ARCHITECTURAL REVIEW BOARD MEETING

PROJECT COMMENTS

PROJECT NUMBER: SP2024-046
PROJECT NAME: Site Plan for 2686 S. Goliad Street
SITE ADDRESS/LOCATIONS: 2686 S GOLIAD ST

PROJECT NUMBER: SP2024-048
PROJECT NAME: Site Plan for River Dog Retreat
SITE ADDRESS/LOCATIONS: 100 S JOHN KING BLVD, ROCKWALL, TX 75087

1 NORTH ELEVATION
SCALE: 3/16" = 1'-0"

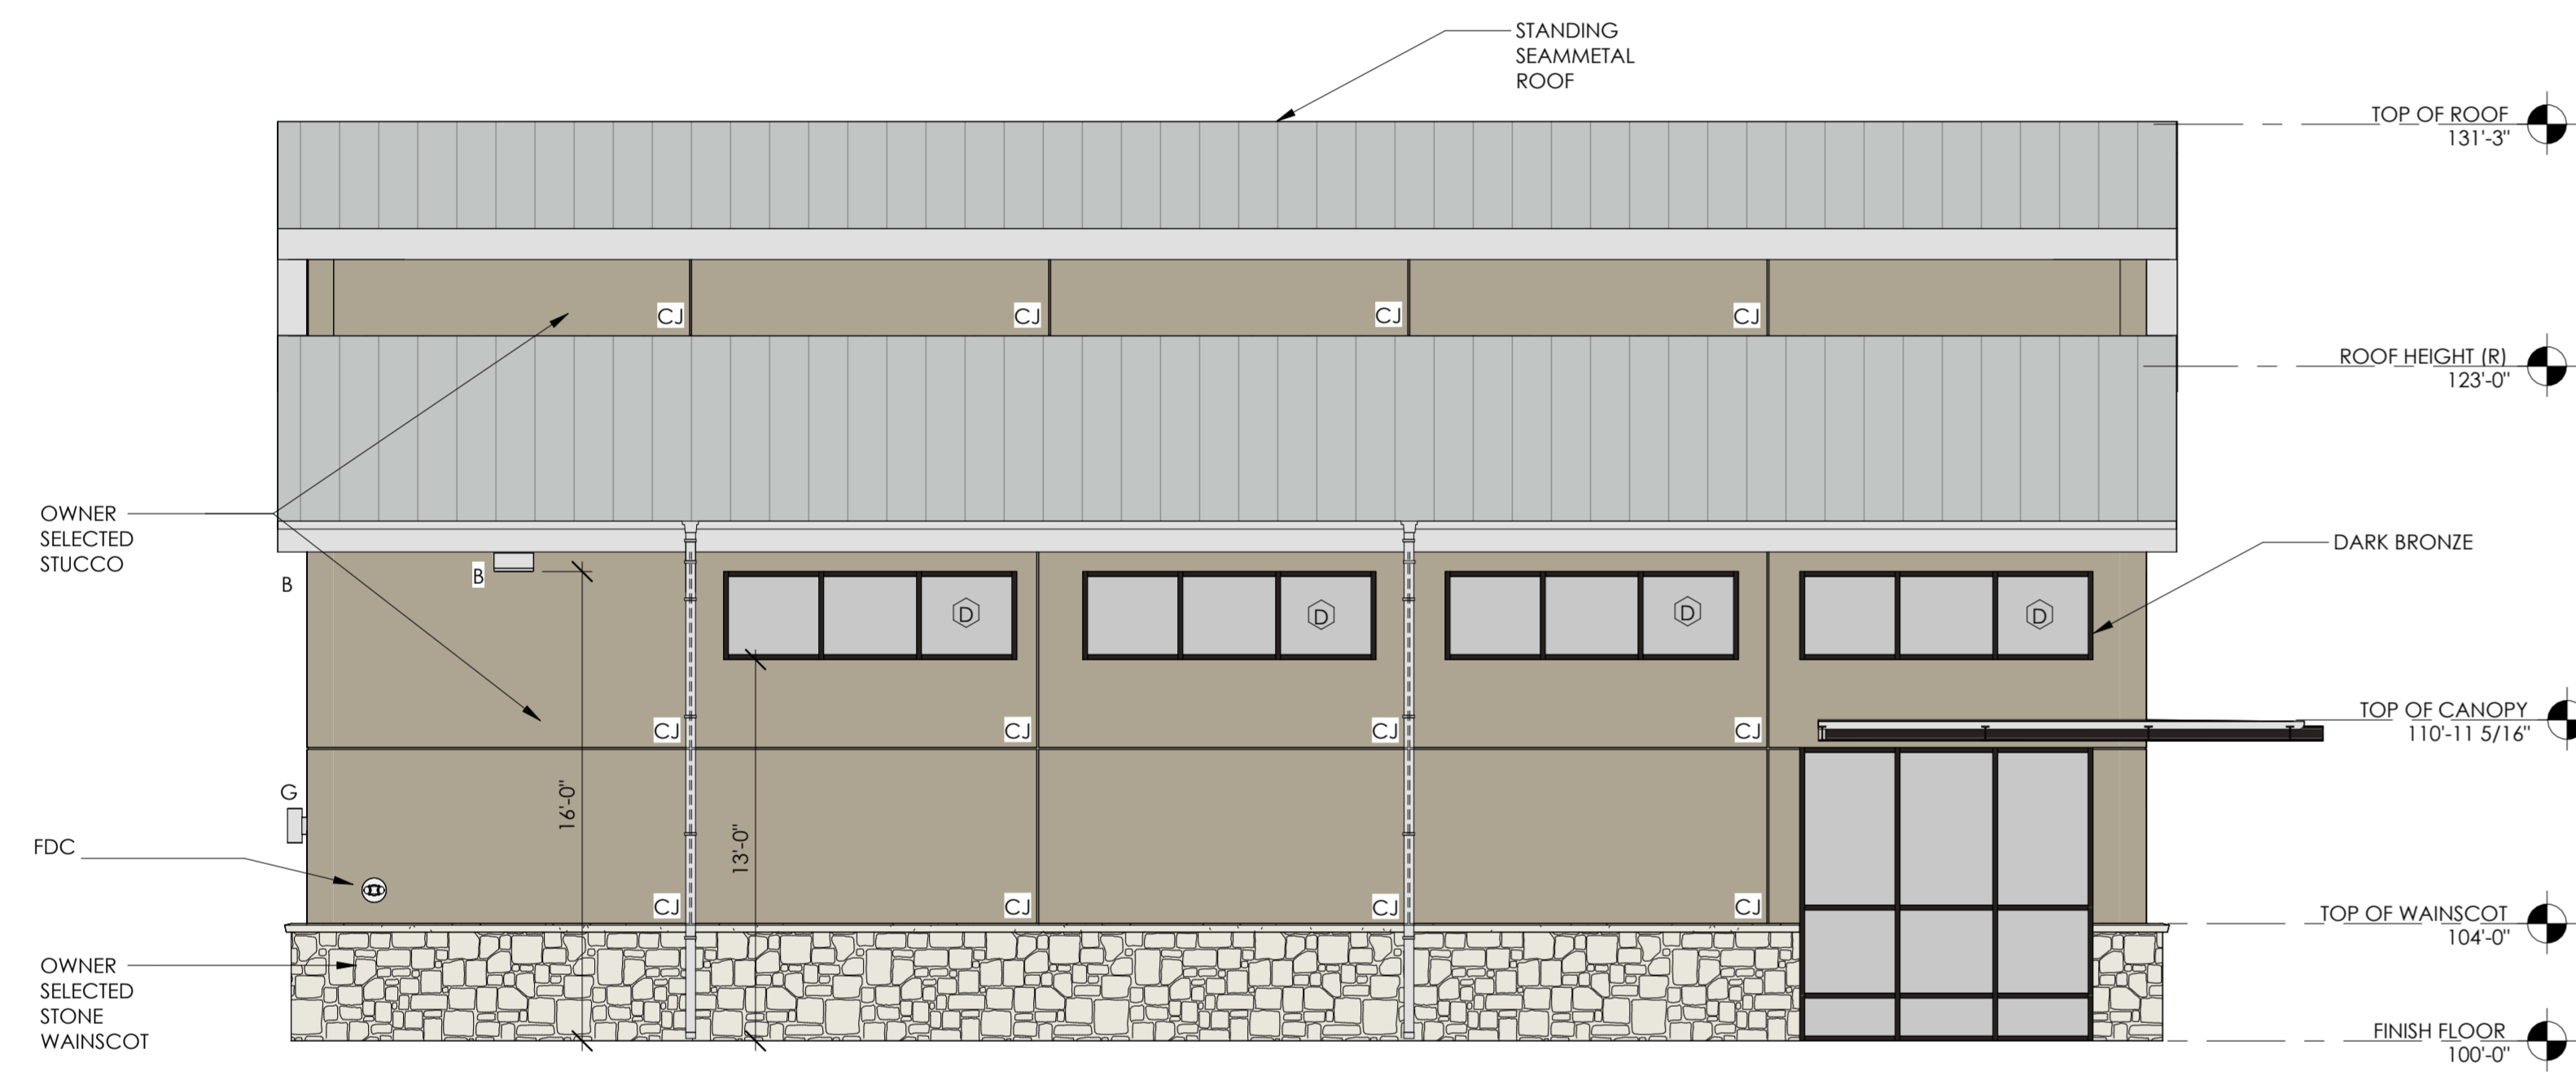
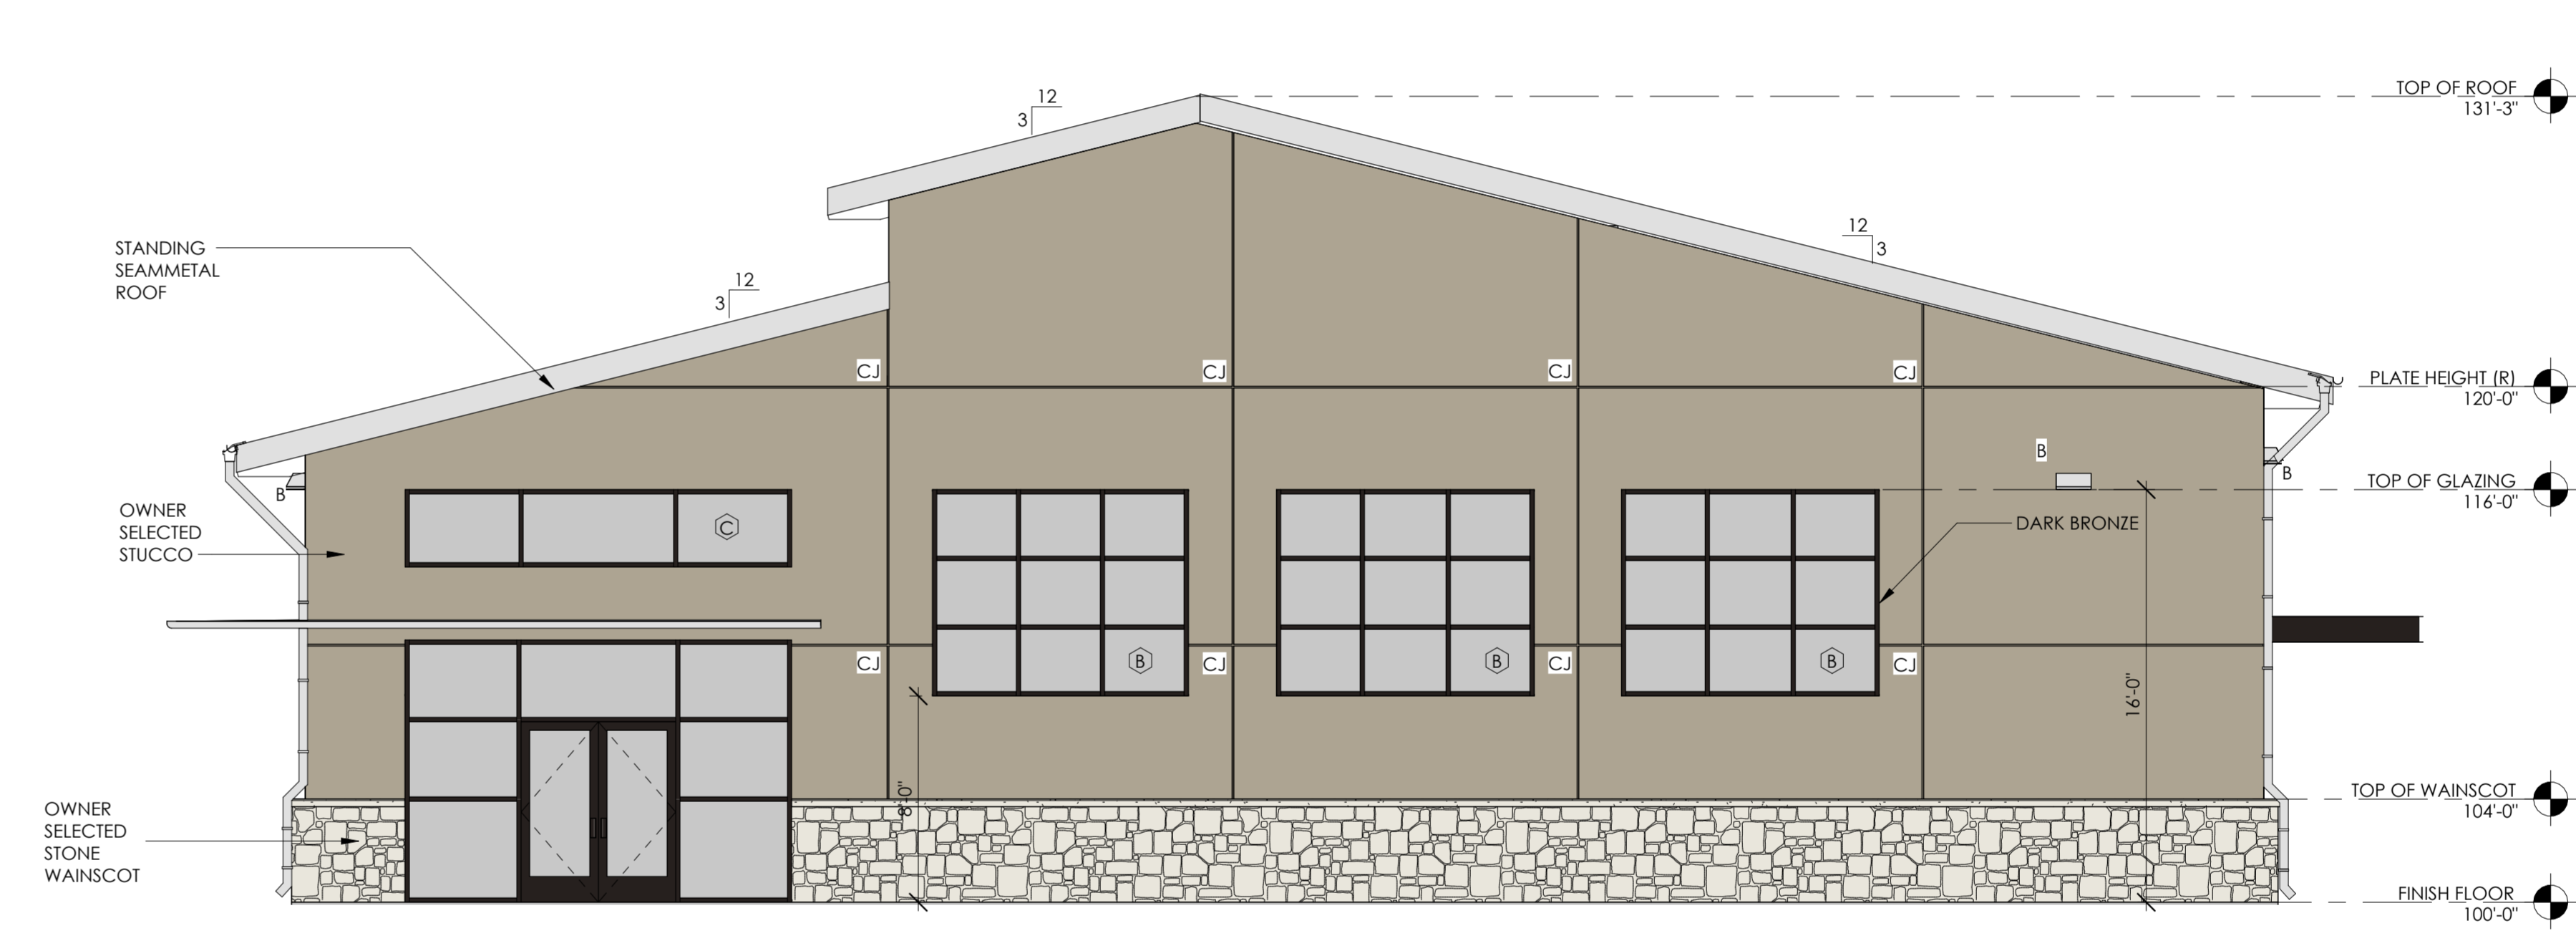
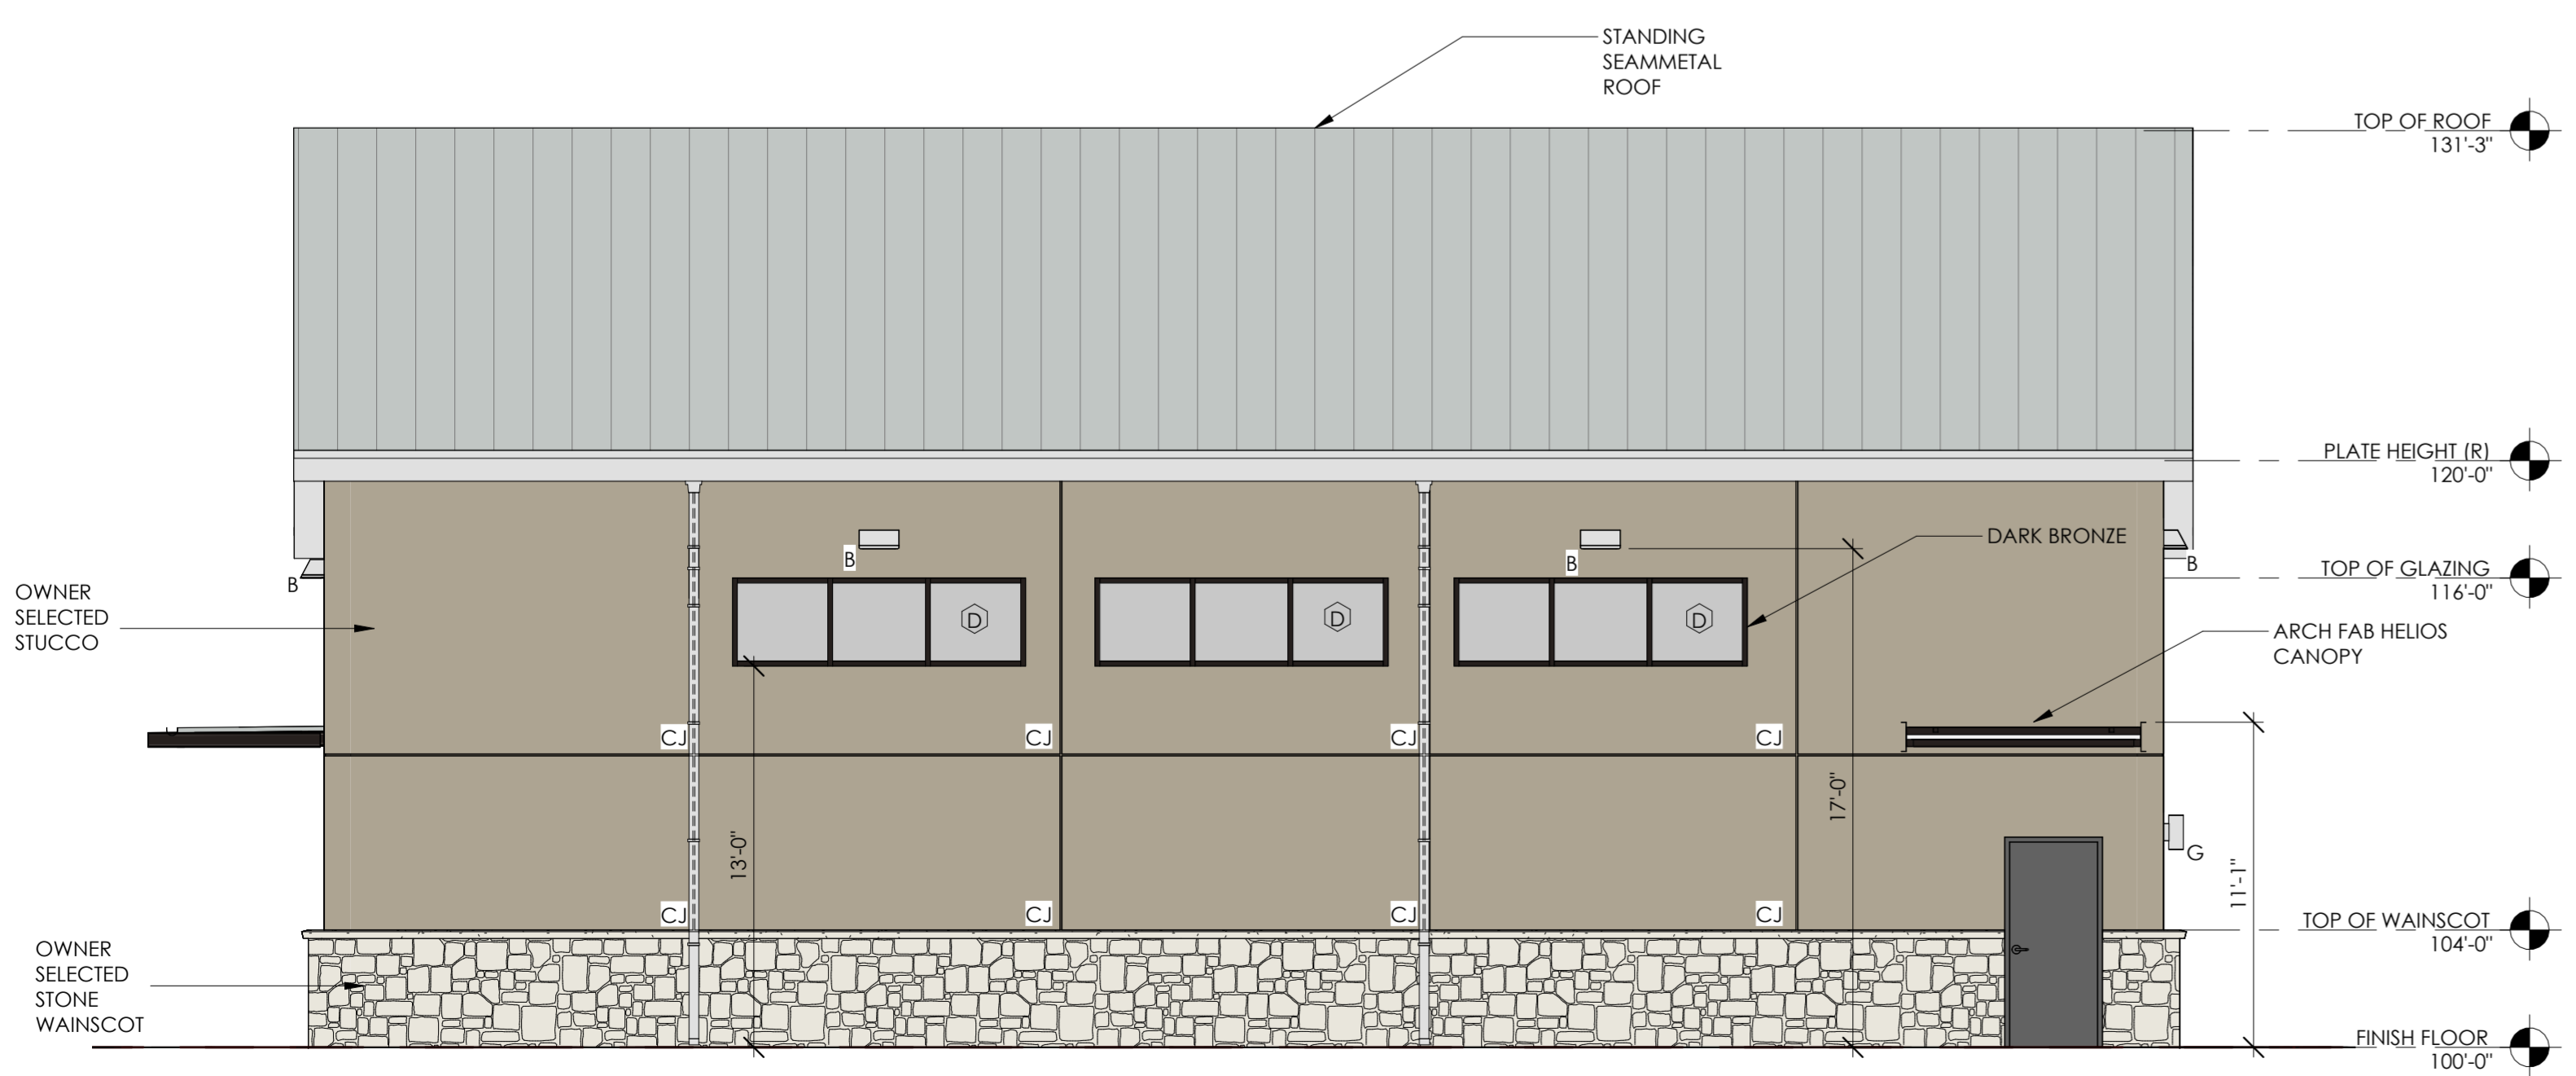
- (1) Please update the table indicating the percentage surface area for each of the proposed materials. This should not include the roof. This will change the material percentages for the stone and stucco. Based on this, the stone may be over the 20% stone requirements (Subsection 04.01, of Article 05, UDC)

- (6) Please provide building elevations for the existing basketball court facility. (Subsection 03.04.B, of Article 11, UDC)
